ADDENDUM TO PARRAMATTA SEPP (HOUSING) COMPLIANCE REPORT

October 2024

Document Number:	SMWSTEDS-SMD-PTA-SN600-AR-RPT-044006
Revision:	B
Date:	October 2024
Suitability Code:	-
TeamBinder Doc No:	Operations, Customer and Place Making
TB Revision:	-

Figure 1-1 Refined Building Envelopes

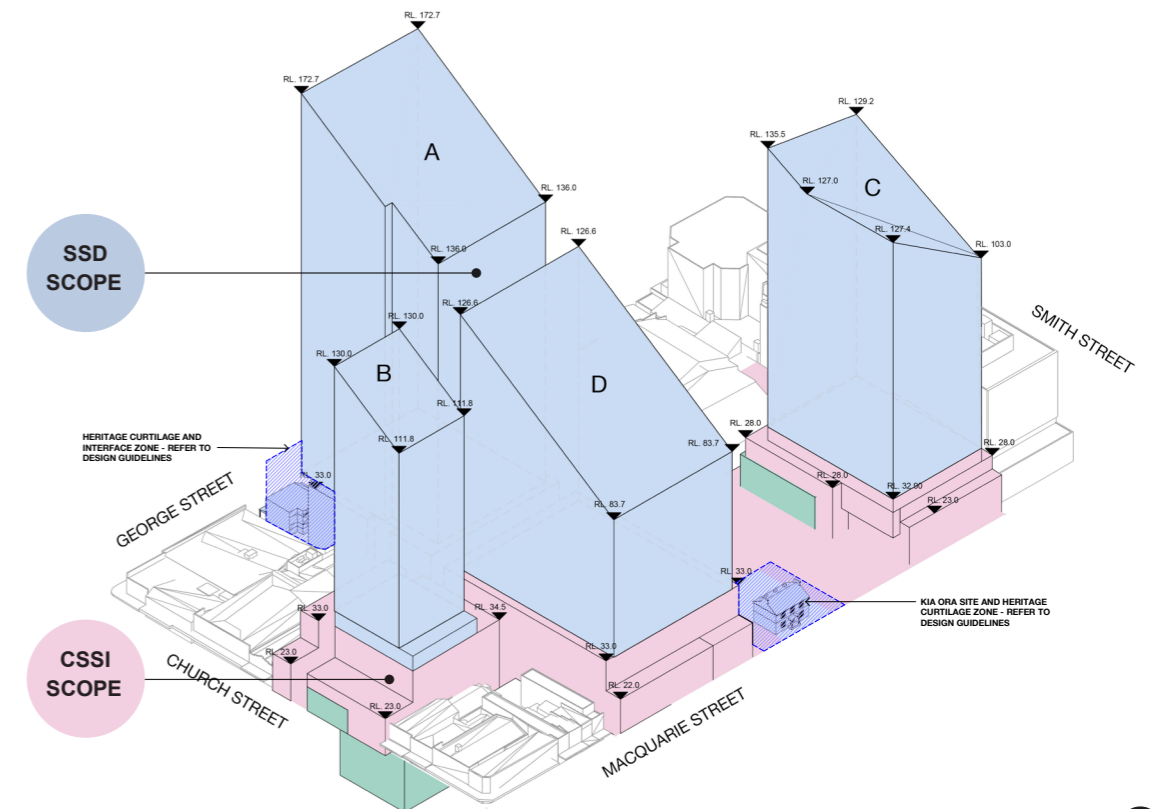
In response to agency advice several refinements have been incorporated into the building envelopes and indicative reference scheme during design development. The key changes are summarised below:

- Building B envelope has been adjusted to increase the southern side setback to an average 6m in line with the Apartment Design Guide objectives.
- Additional retail and commercial floorspace has been located within Building B to meet the minimum 1:1 commercial floorspace requirement of mixed-use land zoning developments.
- The alignment of Horwood Place has been refined in response to CoPC request, straightening the carriageway and providing additional space around Kia Ora.

Figure 2-2 Building B Section, refined 1:750

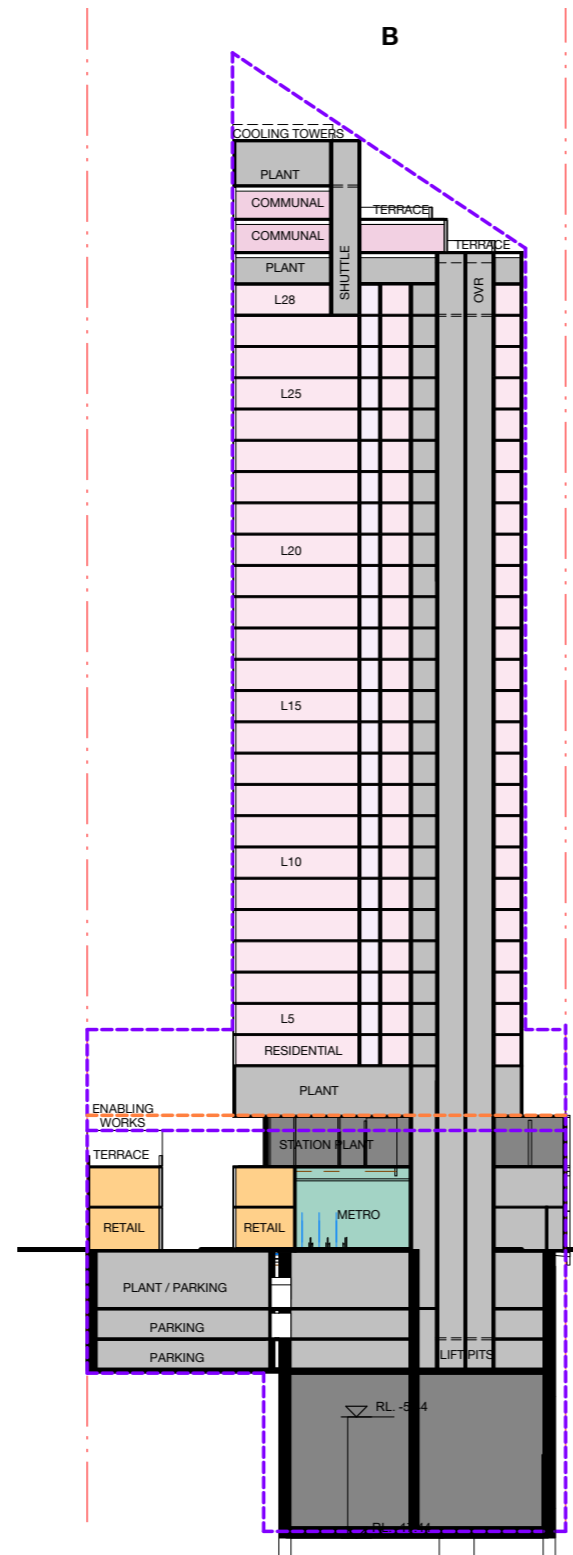
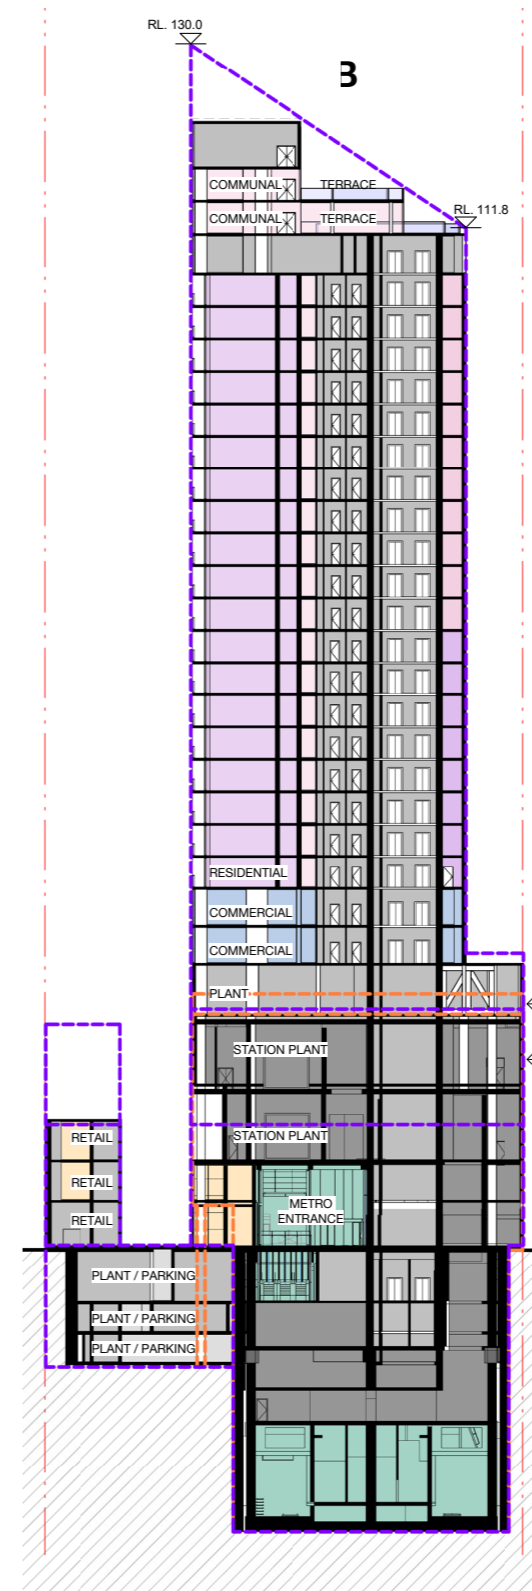
The Concept SSDA sought approval for 1,114m² of commercial / retail GFA within Building B which is less than the 2470m² required to achieve the minimum. A clause 4.6 variation was lodged seeking a variation to this quantity. CoPC have advised that they cannot legally support this variation as this contravenes Clause 4.6(8)(ca) of PLEP, which caps any floor space variation at 5%.

During design development two additional floors of commercial space have been added into the base of the tower at levels 5-6. Additional retail has been added to the northern laneway building at level 02.

The indicative reference scheme now includes a total of 2616m² of non-residential GFA (1494m² commercial GFA and 1122m² of retail GFA). The inclusion of the commercial floors has reduced the total number of apartments down from 145 to 111. It is envisaged that this commercial space could be operated as either:

Figure 2-7 Building B Envelope, refined 1:500

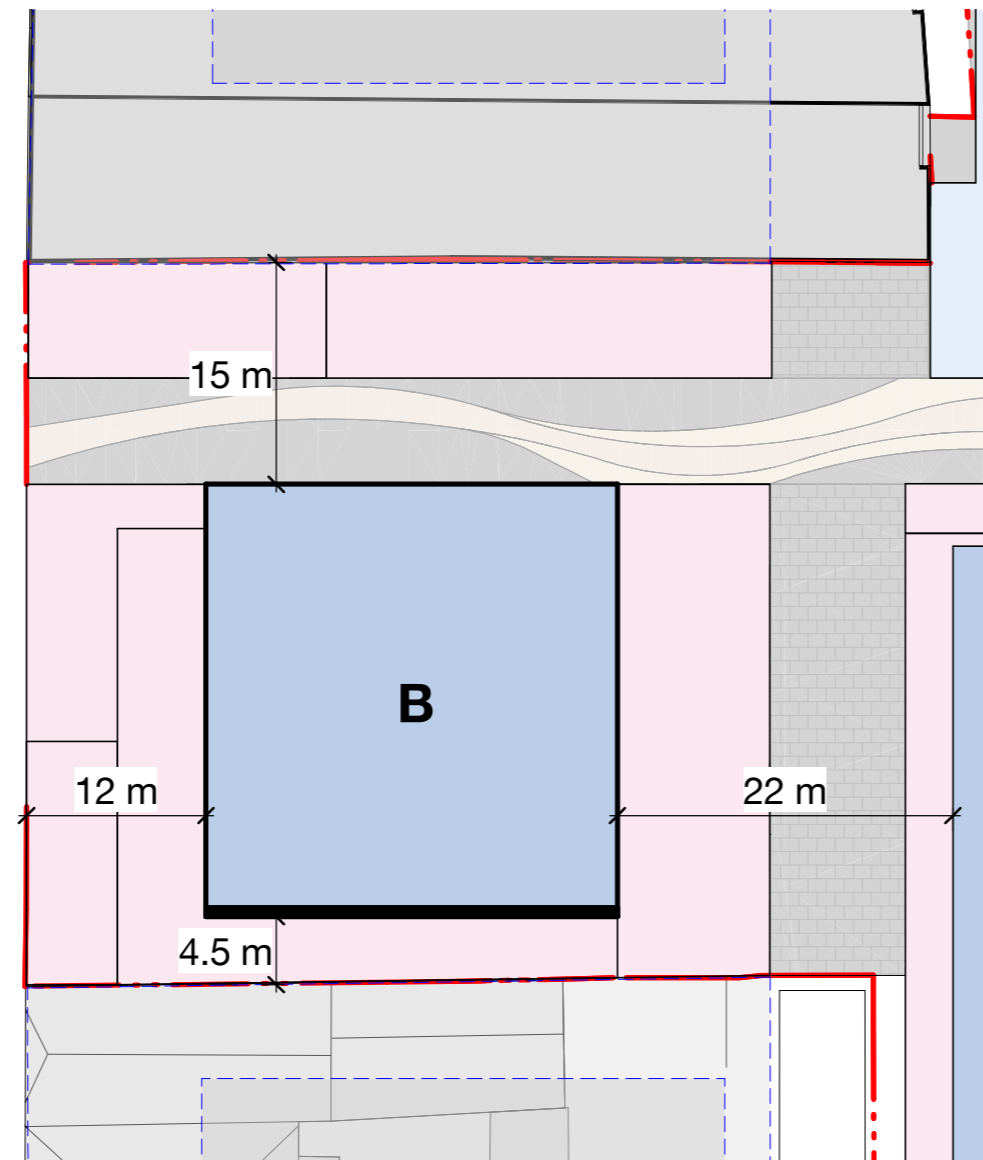
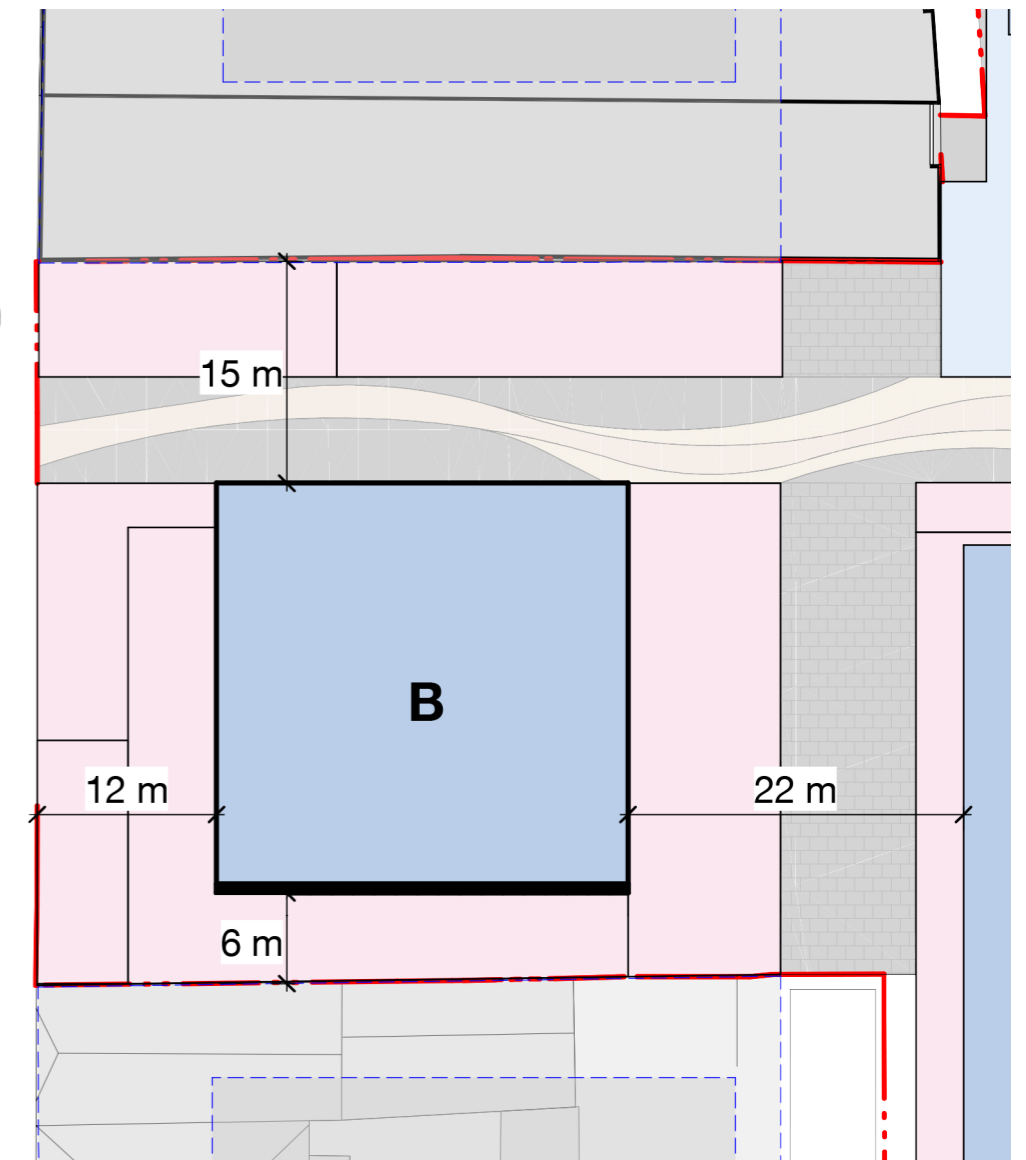
The concept SSDA adopted a 4.5m setback to the southern boundary on the basis that the southern building facade contains no windows. There is significant precedent of blank walls being constructed on boundary lines in dense urban environments.

In light of agency advice received during the submissions process, the southern setback has been increased from 4.5m to 6m. As can be seen from the design criteria in the ADG extract below, 6m is a complying side boundary setback dimension for a building 9+ storeys in height, provided there are no windows to habitable rooms on this frontage.

Figure 2-9 Building B Low rise Floorplate, refined 1:200

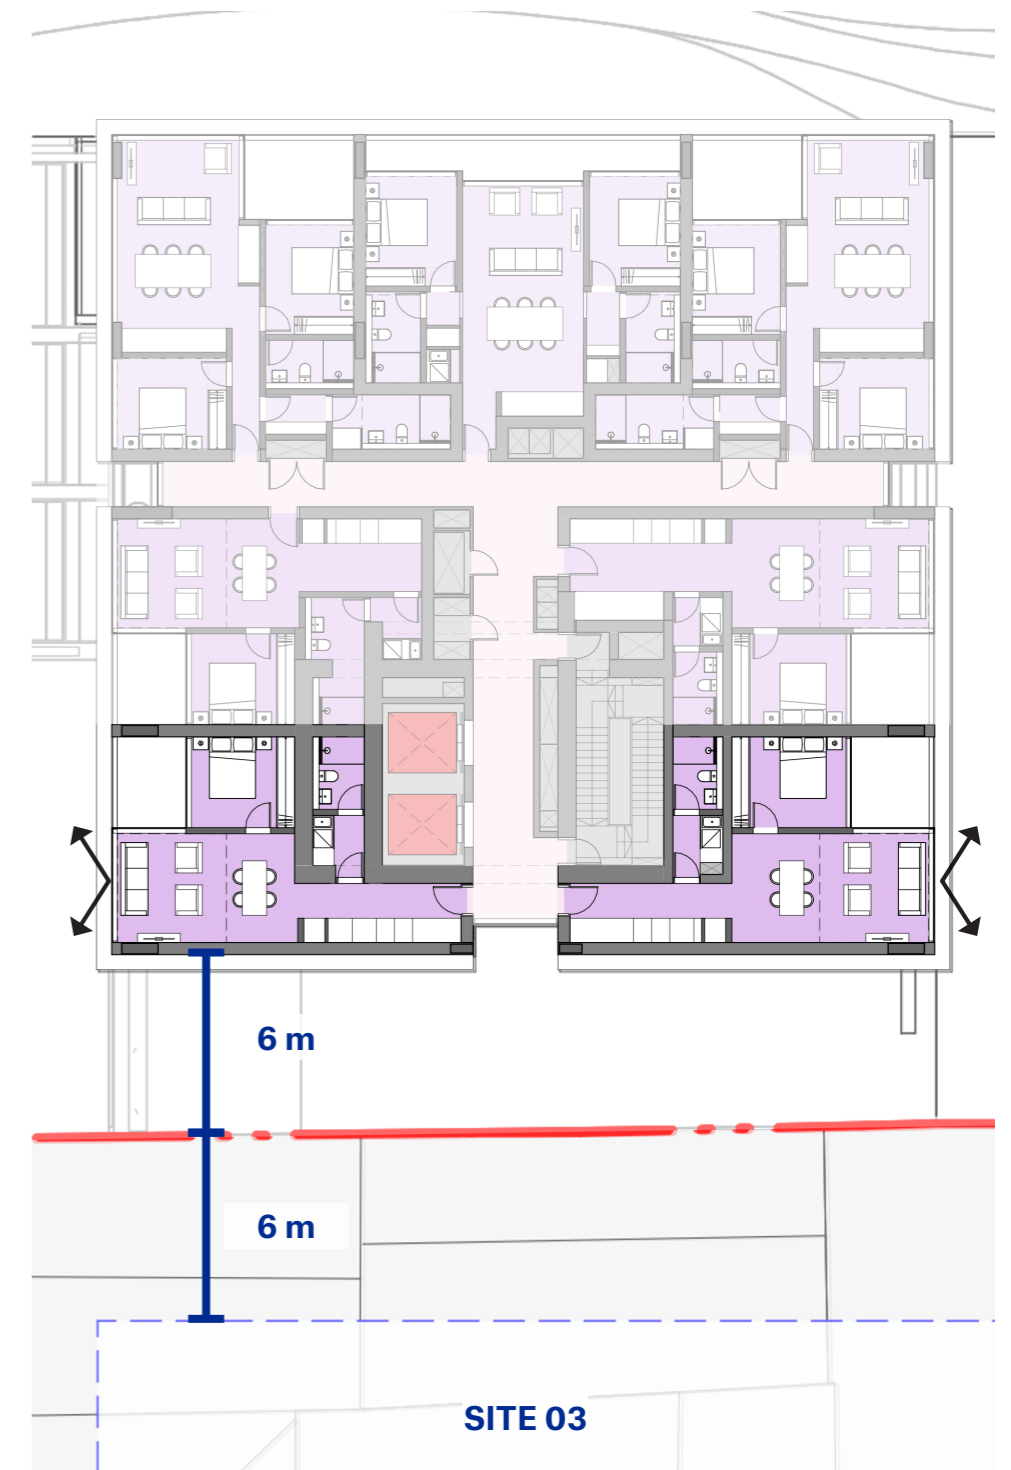
The typical low rise tower plans for both the concept SSDA and the refined indicative reference schemes have been provided. The two southernmost apartments on the floorplate have been designed to maximise residential amenity.

Living rooms, bedrooms and balconies have been oriented to the east and west in order to achieve solar access and provide views and outlook.

There are no windows into apartments along the southern facade. The indicative reference design adopts a glazed window to lift lobby space for purposes of bringing natural light and ventilation into corridor spaces. These circulation spaces are not deemed to be habitable spaces. Future development could omit this window or provide, opaque glass or screening to the space.
